[Docket No. 99–SW–80–AD; Amendment 39–12983; AD 2002–25–07]

Airworthiness Directives; Bell Helicopter Textron Canada Limited Model 206L, L–1, L–3, and L–4 Helicopters

ACTION: Final rule.

Figure 1**BILLING CODE 4910-13-C**

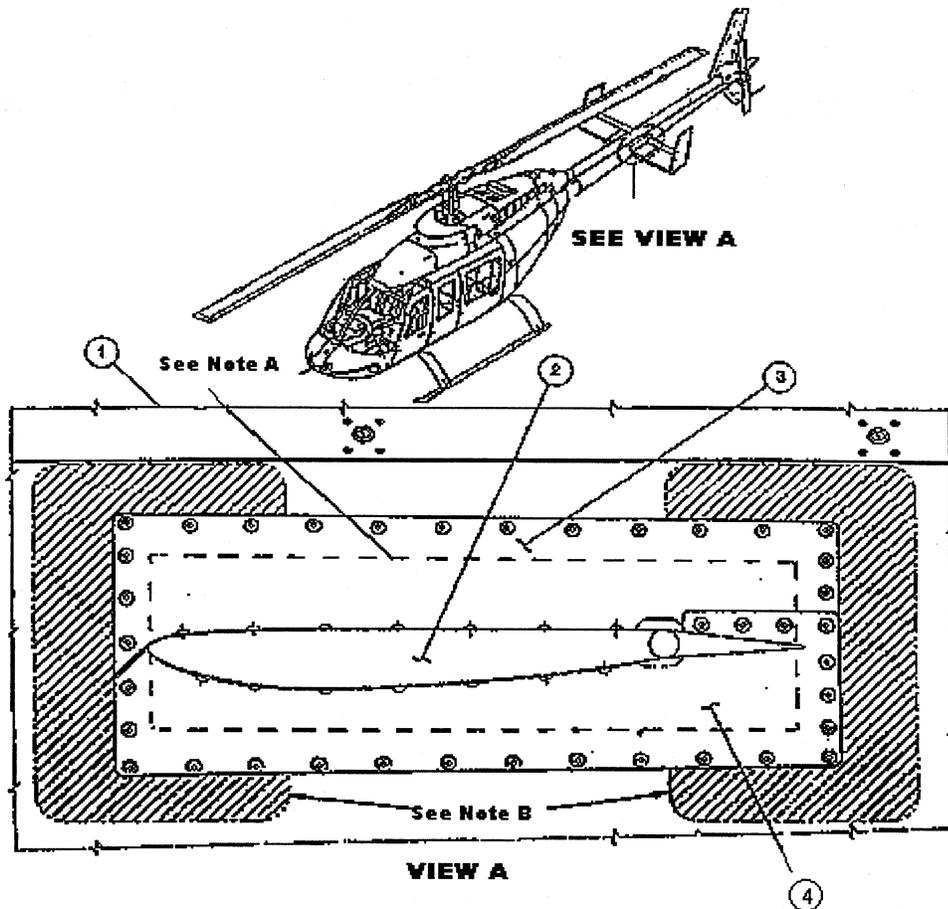
(a) Before further flight and thereafter at intervals not to exceed 10 hours time-in-service (TIS) until accomplishing a one-time fluorescent-penetrant inspection (FPI) required by paragraph (c)(2) of this AD, visually inspect for a crack in the tailboom using a 10-power or higher magnifying glass in the shaded areas as depicted in Figure 1 of this AD:

(b) At intervals not to exceed 5 hours TIS, visually check for a crack in the tailboom in the shaded areas as depicted in Figure 1 of this AD. The visual check may be performed by an owner/operator (pilot) holding at least a private pilot certificate and must be entered

(2) Perform a one-time FPI of the edges of the tailboom skins for any crack around the left and right horizontal stabilizer openings as shown in Figure 1 of this AD. Remove paint and primer to inspect the edges and

exterior skin surface in the skin area at least 3/4 inch around the edges of the horizontal stabilizer openings as shown in Figure 1 of this AD.

(2) Visually inspect the entire edge of the horizontal stabilizer opening on both sides of the tailboom for any crack using a 10-power or higher magnifying glass as shown in Figure 1 of this AD.

- A. Inspect entire edge of stabilizer opening on both sides of the tailboom.
- B. Inspect for a crack in these two areas on both sides of the tailboom
